Commonwealth Edison

Subject: Byron Generating Station Units 1 and 2
Braidwood Generating Station Units 1 and 2
HVAC Systems
NRC Docket Nos. 50-454/455 and 50-456/457

This letter provides additional information regarding the testing of filters and ducts in the Byron/Braidwood HVAC filter systems. This information is supplied at the request of the NRC Staff to address the questions regarding FSAR commitments.

FIGURE 1
AUXILIARY BUILDING HVAC SYSTEM

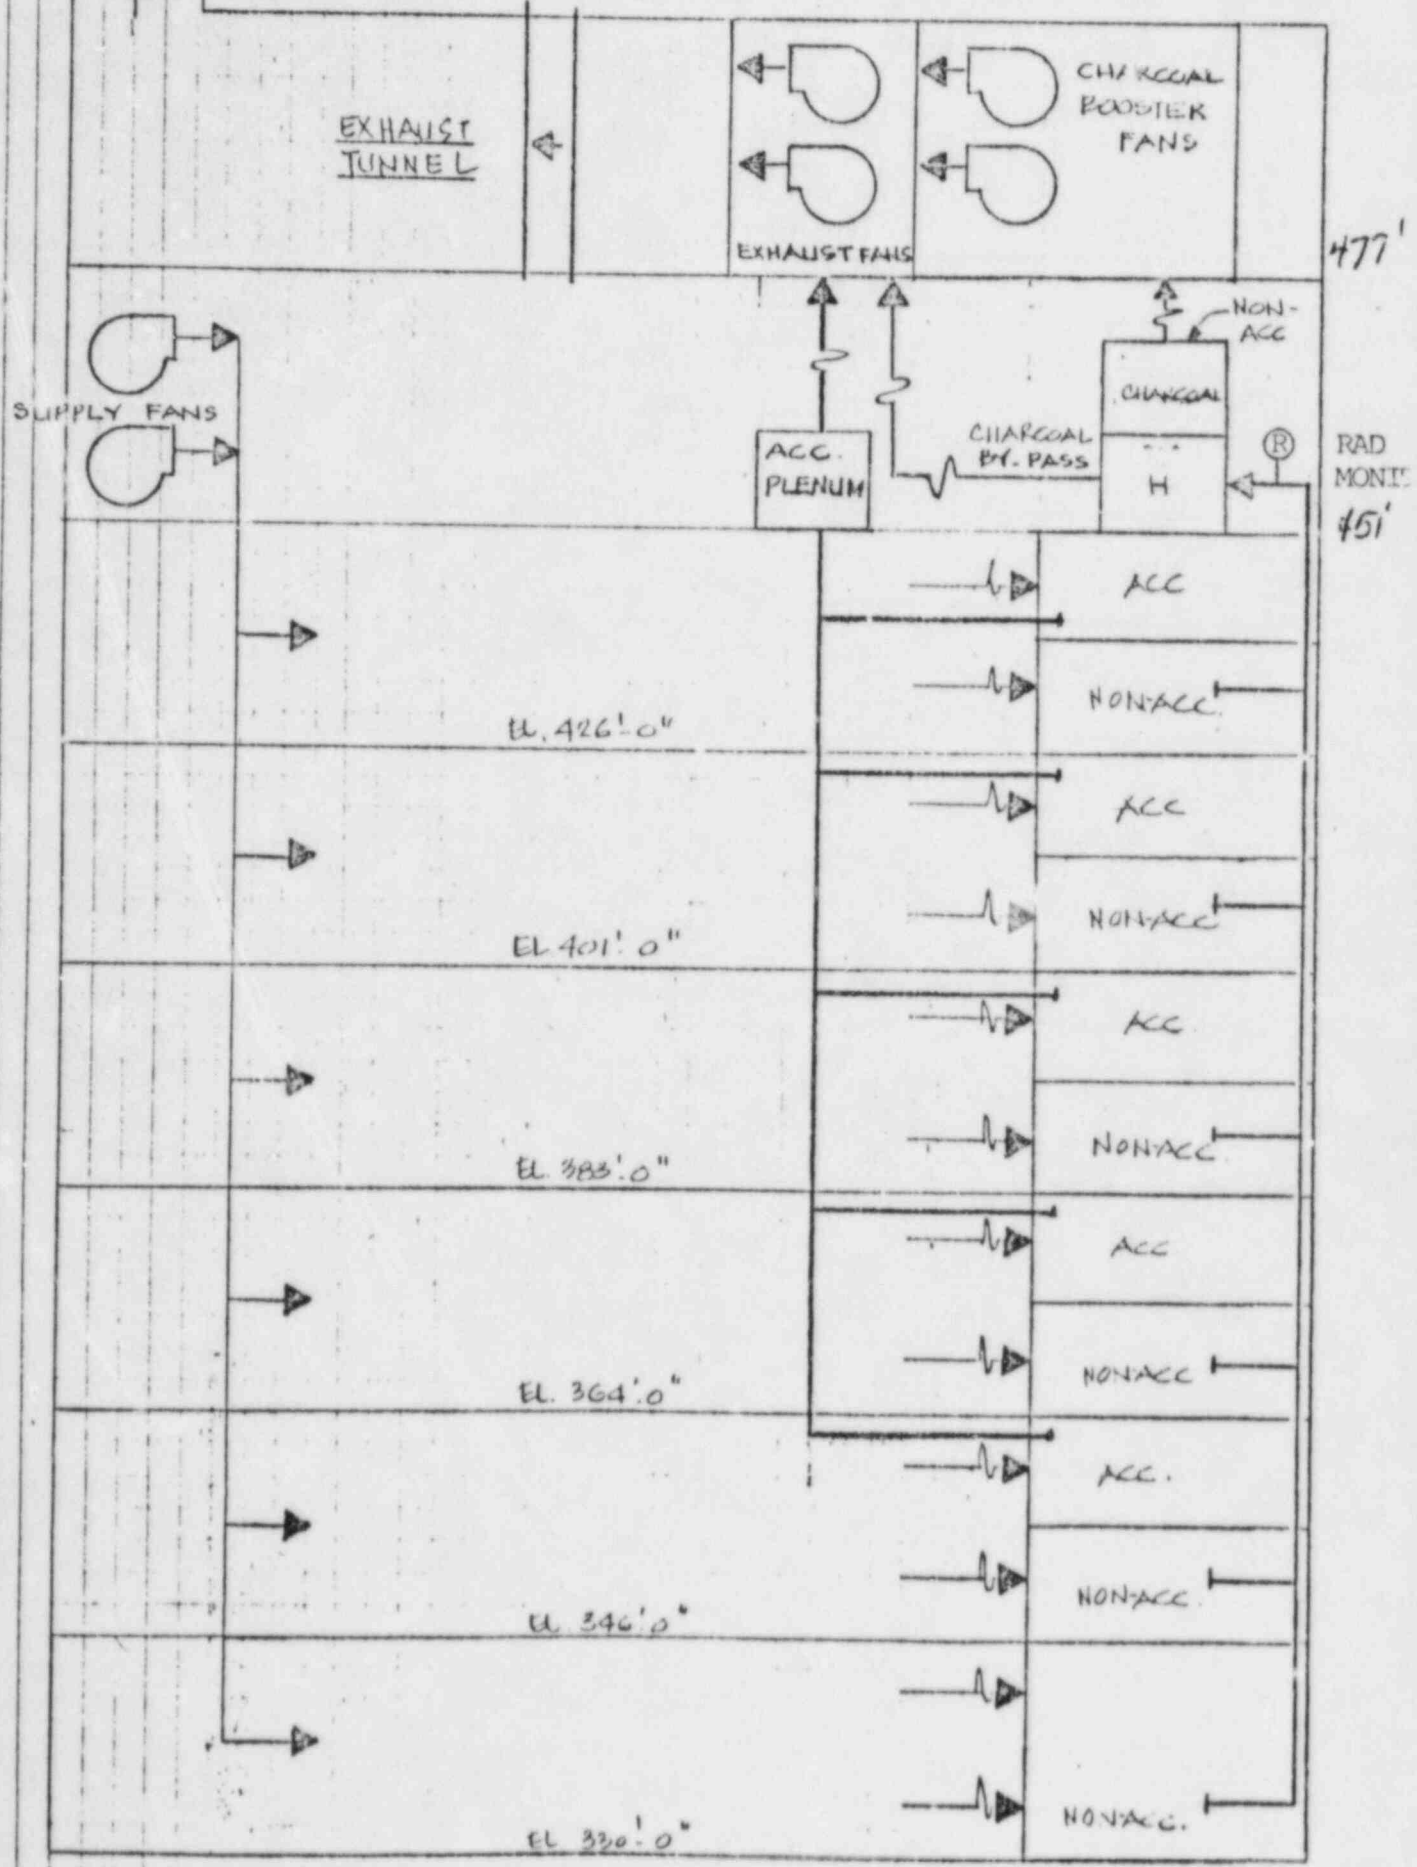
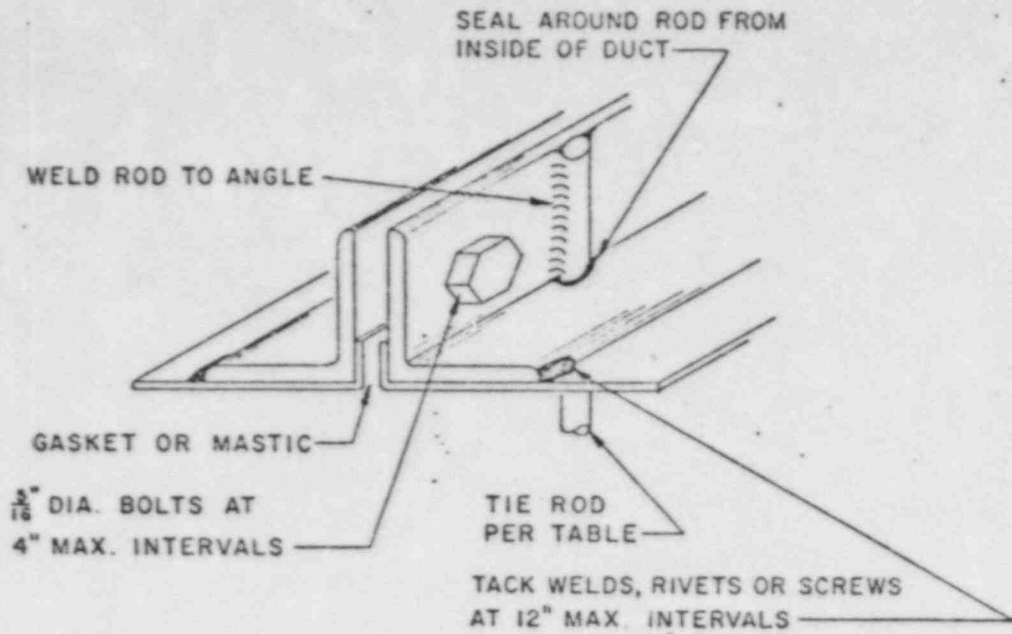
"...THE APPLICANT HAS INDICATED THAT THE DUCTWORK WILL NOT BE LEAK TESTED IN ACCORDANCE WITH ANSI N509-76 AND HAS NOT PROPOSED ANY ALTERNATIVE TESTING FOR THE DUCTWORK; EVEN THE LESS RIGOROUS TESTING OF ANSI/ASME N509-80. THE STAFF INITIALLY ACCEPTED THE APPLICANT'S EXCEPTION TO LEAK TESTING THE DUCTWORK BECAUSE ALL RADIOACTIVITY WOULD LEAK INTO THE DUCTWORK AND WOULD BE FILTERED. HOWEVER, FURTHER CONSIDERATION OF THIS EXCEPTION HAS RAISED OTHER QUESTIONS..."

3.1 "OBVIOUSLY, THE ADDITIONAL IN-LEAKAGE TO THE DUCTS WILL RESULT IN AN INCREASE IN THE QUANTITY OF RADIOACTIVITY RELEASED OFFSITE IN THE EVENT OF AN ACCIDENT."

3.2 "HOWEVER, MORE IMPORTANTLY, A GREATER PROBLEM EXISTS WITH RESPECT TO THE POTENTIAL DEGRADATION OF THE CHARCOAL IN THE ESF FILTER TRAINS DUE TO THE UNKNOWN TRANSMISSION OF FUMES FROM PAINTING, FIRES OR CHEMICAL RELEASES VIA THE LEAKY DUCTWORK. SUCH A TRANSMISSION COULD BE CHRONIC AND PLANT PERSONNEL MAY NEVER LABORATORY-TEST THE CHARCOAL UNTIL THE SCHEDULED REFUELING OUTAGE. IN THE INTERVENING MONTHS, THE PLANT MAY HAVE BEEN OPERATING WITH CHARCOAL INCAPABLE OF PERFORMING AT THE EFFICIENCY ASSUMED IN THE STAFF'S SER.

3.3 "...THE STAFF IS ALSO CONCERNED THAT THE RELATIVE HUMIDITY SEEN BY THE CHARCOAL ADSORBERS MAY BE ALTERED DUE TO THE VARIATION IN THE FLOW RATE BROUGHT ABOUT BY THIS DUCTWORK IN-LEAKAGE FROM THE VARIOUS SOURCES TO THE FILTRATION UNITS AND THAT THE ANALYSES PRESENTED BY THE APPLICANT JUSTIFYING THE EXCLUSION OF ELECTRICAL HEATERS MAY BE INVALIDATED."

"THEREFORE, IT IS THE STAFF'S POSITION THAT THE DUCTWORK ASSOCIATED WITH THE ESF FILTER SYSTEMS MUST BE PRESSURIZED AND ALL AUDIBLE LEAKS MUST BE LOCATED AND SEALED. FURTHERMORE, IN ACCORDANCE WITH ANSI/ASME N509-80, ALL DUCTS MUST BE SUBJECTED TO A QUANTITATIVE MEASUREMENT OF LEAKAGE UNLESS THE DUCT IS LOCATED WITHIN A CONTAMINATED SPACE OR PROTECTED SPACE (AS DEFINED IN ANSI/ASME N509-80) OR HAS A LENGTH OF THIRTY FEET OR LESS MEASURED EITHER FROM THE FAN OR THE AIR CLEANING UNIT TO ITS TERMINUS. THE ALLOWABLE LEAK RATES FOR THE DUCTS SHOULD BE IN CONFORMANCE WITH SECTION 4.12 OF ANSI N509-80."

FIGURE 1 IS A SIMPLIFIED SCHEMATIC WHICH SHOWS ONE-HALF OF THE AUXILIARY BUILDING SYSTEM, WHICH IS SHARED BETWEEN UNIT 1 AND UNIT 2.

THE AUXILIARY BUILDING HVAC SYSTEM SERVES MULTIPLE FUNCTIONS. IT OPERATES DURING NORMAL PLANT OPERATION TO PROVIDE CONDITIONED AIR TO THE GENERAL AREAS FOR COOLING PURPOSES. THE AIR SUPPLIED TO THE GENERAL AREA IS THEN INDUCED INTO CUBICLES WHICH HAVE BEEN CATEGORIZED AS "ACCESSIBLE" AND "NON-ACCESSIBLE." THE "NON-ACCESSIBLE" CUBICLES, SHOWN ON THE ATTACHED, ARE SO CATEGORIZED DUE TO THEIR POTENTIAL FOR BECOMING CONTAMINATED DURING EITHER NORMAL OPERATION OR POST-ACCIDENT. AS YOU CAN SEE IN THIS LISTING OF NON-ACCESSIBLE CUBICLES, SEVERAL CUBICLES OTHER THAN THE ESF PUMP CUBICLES ARE CATEGORIZED AS "NON-ACCESSIBLE." ALSO, "NON-ACCESSIBLE" CUBICLES OR AREAS ARE FOUND ON EVERY ELEVATION OF THE AUXILIARY BUILDING.

THE AIR IS INDUCED INTO THE CUBICLES BY THE AUXILIARY BUILDING EXHAUST SYSTEM, WHICH DRAWS AIR FROM EACH CUBICLE, THROUGH PREFILTERS AND HEPA'S AND DISCHARGES THAT AIR TO THE OUTDOORS THROUGH THE PLANT VENTILATION STACK.

THE AIR DRAWN FROM THE "NON-ACCESSIBLE" CUBICLES IS MONITORED BY RADIATION MONITORS LOCATED IN THE DUCTS, UPSTREAM OF THE FILTER UNITS, AS WELL AS IN THE PLANT VENT STACKS. ON A HIGH RADIATION SIGNAL, THE CONTROL ROOM OPERATOR CAN DIRECT THE "NON-ACCESSIBLE" AREA EXHAUST THROUGH CHARCOAL AND HEPA FILTERS. NORMALLY,

FIGURE 4

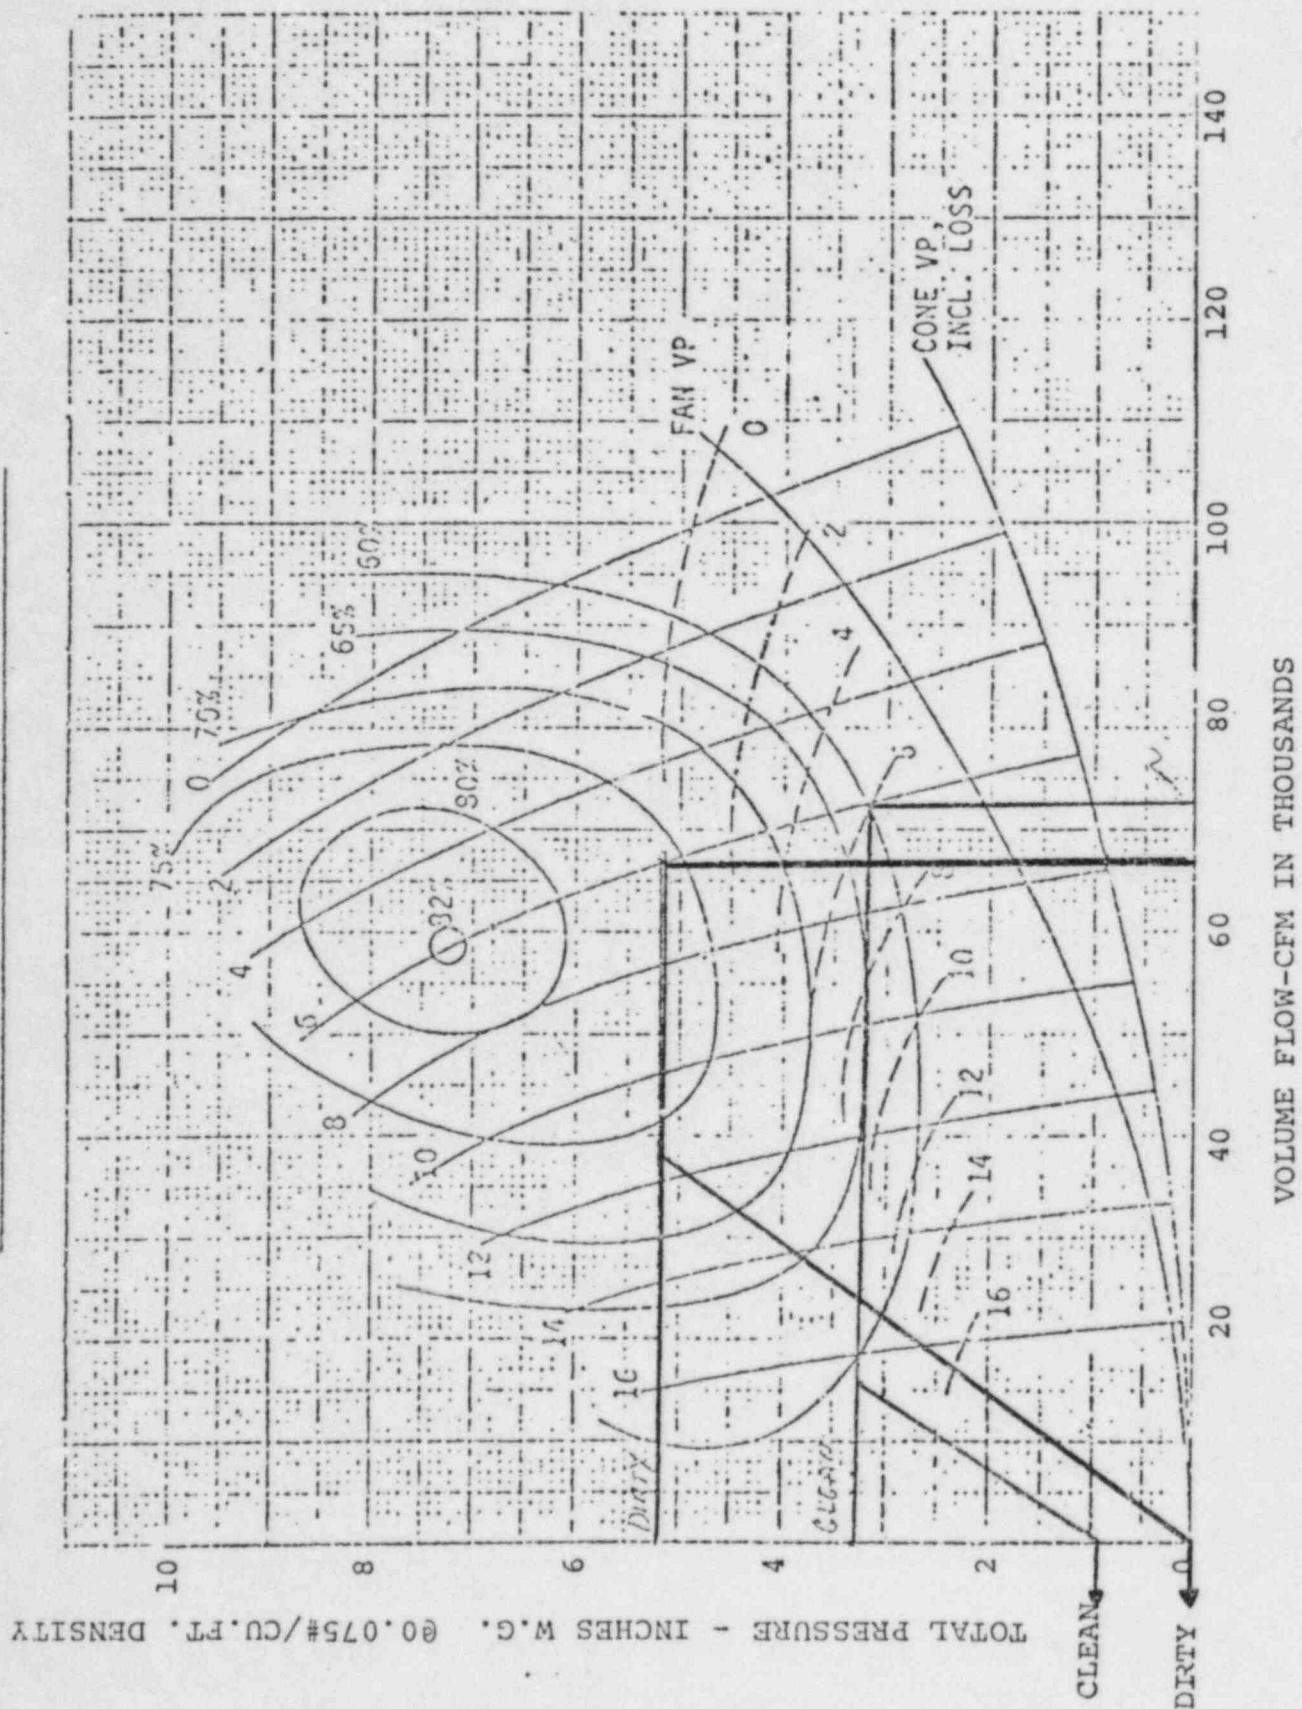
"...IT IS NOT APPARENT TO THE STAFF HOW THE APPLICANT WILL BE ABLE TO ENSURE THAT THE FLOW RATE IN THE NON-ACCESSIBLE AREA EXHAUST FILTER SYSTEMS AND THE CONTROL ROOM EMERGENCY MAKE-UP AIR FILTERS IS MAINTAINED WITHIN +10% OF ITS DESIGN FLOW WHEN FLOW IS ONLY SENSED. IT MUST BE ENSURED THAT THE RESIDENCE TIME IN THE CHARCOAL ADSORBER IS MAINTAINED AT THE DESIGN VALUE OF 0.25 SECONDS PER TWO INCHES OF CHARCOAL AND THAT THE FLOW RATE CAPABILITY OF THE HEPA FILTERS IS NOT EXCEEDED. THEREFORE, THE APPLICANT SHOULD ADDRESS HOW FLOW WILL BE MAINTAINED TO SATISFY THESE CONDITIONS..."; "...THE APPLICANT SHOULD ALSO ADDRESS THE RECORDING OF FLOW FOR THE FUEL HANDLING BUILDING FILTRATION UNITS."

FIGURES 4 AND 5 PROVIDE THE FAN NORMAL OPERATING POINTS BETWEEN THE CLEAN AND DIRTY FILTER RESISTANCE IN THE SYSTEM FOR NON-ACCESSIBLE FILTERS AND FUEL HANDLING BUILDING EXHAUST FILTERS, RESPECTIVELY. AS CAN BE SEEN FROM THESE CURVES, FOR SYSTEM NORMAL OPERATING CONDITIONS, THE FLOW VARIATION BETWEEN TWO POINTS IS LESS THAN 10%, THUS ASSURING DESIGN FLOW.

FOR ANY POSTULATED SYSTEM UPSET CONDITIONS, THE FAN WILL BE OPERATING BEYOND THE TWO OPERATING POINTS, WHICH WILL THEN BE ALARMED AT MCP BY EITHER THE HIGH OR LOW ΔP ALARM OF THE FAN THUS ALERTING THE OPERATOR FOR FURTHER ACTION.
